Interactive comment on "Characteristics and drivers of baseflow response in 183 Australian catchments" *by* A. I. J. M. van Dijk

Anonymous Referee #3

Review report on manuscript Characteristics and drivers of baseflow response in 183 Australian catchments by van Dijk

Fig. 1.

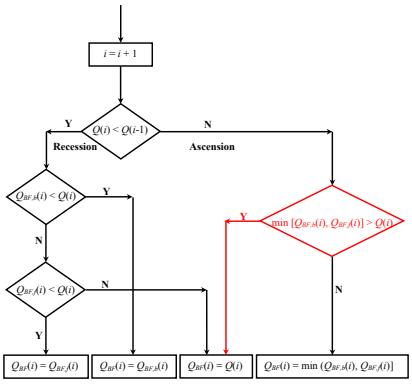
Section 3.4: A simple flow chart can be provided instead of or together with the decision tree. A simple chart based on the decision tree in the manuscript is made available in this report. Two questions for the rising limb of the hydrograph: (1) why does the author prefer the backward filter? (2) In the decision tree, there is an open point. The case when neither the forward nor the backward baseflow is less than streamflow is not mentioned. Although it is physically clear that baseflow cannot exceed streamflow in the river, this should be mentioned for the completeness of the decision tree (See red

part in the flow chart).
